ROBINSON TOWNSHIP PLANNING COMMISSION

February 24, 2026

MEMORANDUM

To: Robinson Township Planning Commission
From: Gregory L. Ransford, MPA 
Date: February 4, 2026
Re: Boersen Special Land Use and site plan application in the E-1 Overlay District

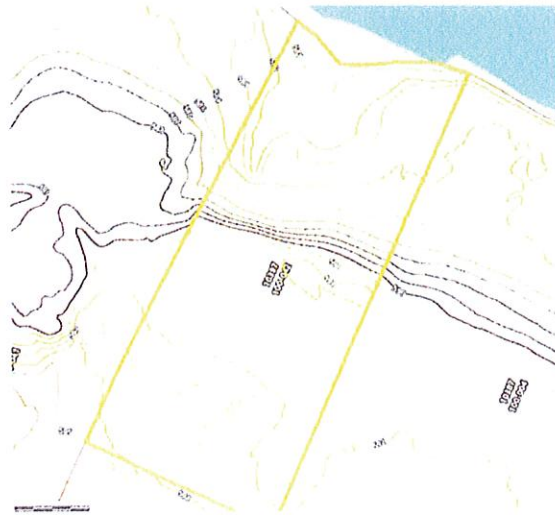
- (A) The Detailed Site Plan shall be of a scale not greater than one (1) inch equals twenty (20) feet nor less than one (1) inch equals two hundred (200) feet, of such accuracy that the Planning Commission can readily interpret it, and shall include more than one (1) drawing if required for clarity.

We understand that the Planning Commission is attempting to accommodate a recommendation at their February meeting to also accommodate a public hearing at the Board of Trustees meeting in March. While unfortunately the site plan scale appears to be incorrect given that it is on a modified (shrunk) survey and we would ordinarily not accept this result, dimensionally the site plan is very detailed and accurate regarding the existing structures and proposed improvements. Given your intended timetable, we have accepted this site plan. As such, this standard may be met.

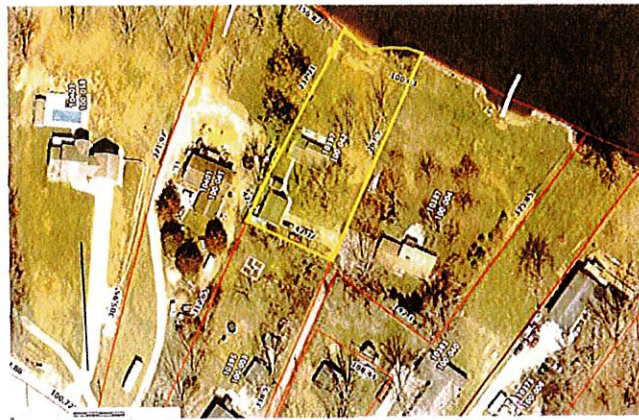
- (E) The Detailed Site Plan shall identify properties adjacent to the site, the uses of those properties, and any structures within one hundred (100) feet of the site's boundaries.

All surrounding properties contain single-family dwellings and accessory buildings. Shown below are the aforementioned within 100 feet of the site (subject property is in yellow). As such, this standard may be met.

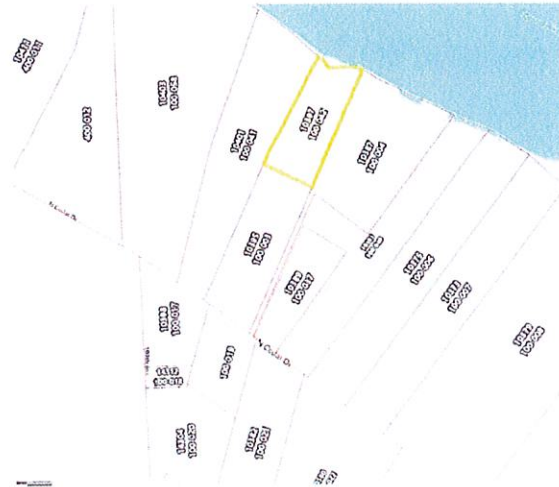
- (H) The Detailed Site Plan shall show the proposed location, use and size of open spaces and the location of any landscaping, screening, buffering, fences or walls on the site. Any proposed alterations to the topography, vegetation and other natural features of the site shall be indicated.

As the applicant indicates within the Project Summary – Special Use Permit Application, only a Chinese Elm tree will be removed. No screening is proposed. As such, this standard may be met.

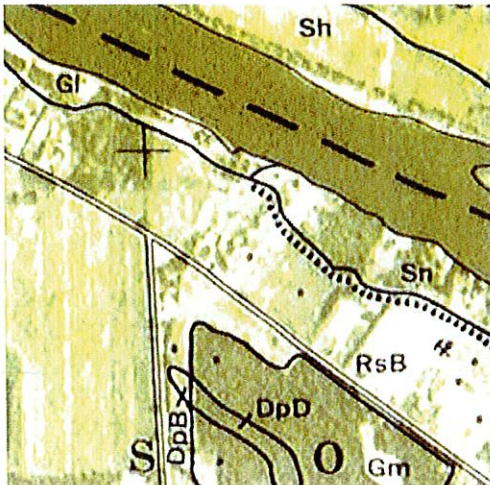
- (L) The Detailed Site Plan shall show the elevation and location of existing and proposed storm water drainage courses and County drains.

No county drainage courses are in the area and none are proposed. As such, this standard appears not to apply.
